Equalizer Optimization for TDECQ

IEEE 802.3dj May Meeting

Comments Addressed: 92, 395, 396, 478

Proposed Changes to p.479

Figure 180-10

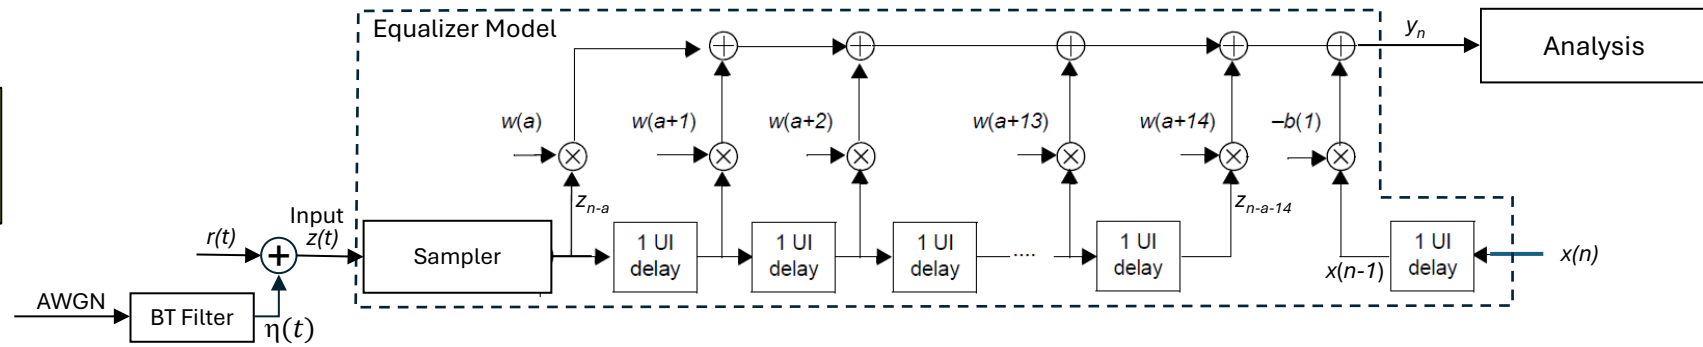
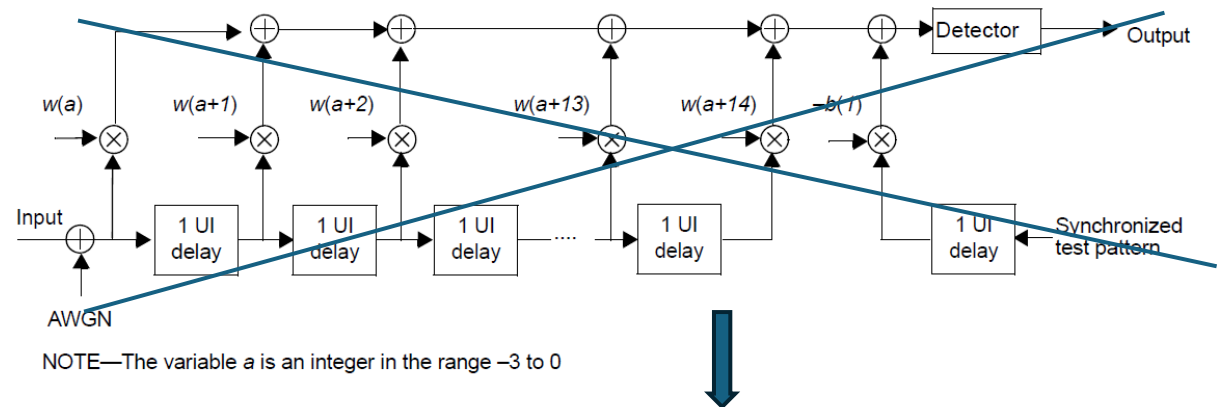
The reference equalizer is a T-spaced discrete-time equalizer with 15 feedforward taps and a single decision feedback tap, where T is the symbol period. Equalizer coefficient constraints are given in Table 180-16. The reference equalizer may be implemented in the oscilloscope. The decisions fed back in the equalizer are modeled as being correct, so the equalizer is modeled as shown in Figure 180-10, where $x(n)$ is the n^{th} symbol in the test pattern sequence, $r(t)$ is the output of the reference receiver defined in 180.9.2, $\eta(t)$ is colored Gaussian noise, $z(t) = r(t) + \eta(t)$, $z_n = z(nT + \phi)$, where $0 \leq \phi < T$, and y_n is the equalizer output corresponding to $x(n)$. The Bessel-Thomson (BT) filter shown is identical to that in 180.9.2. The received signal $r(t)$ is aligned with the test pattern such that $r(nT)$ corresponds to $x(n)$.

The reference equalizer is a 15-tap, T-spaced, feed-forward equalizer (FFE), followed by a 1-tap decision feedback equalizer (DFE), where T is the symbol period, with equalizer coefficient constraints as shown in Table 180-16. The reference equalizer may be implemented in the oscilloscope.
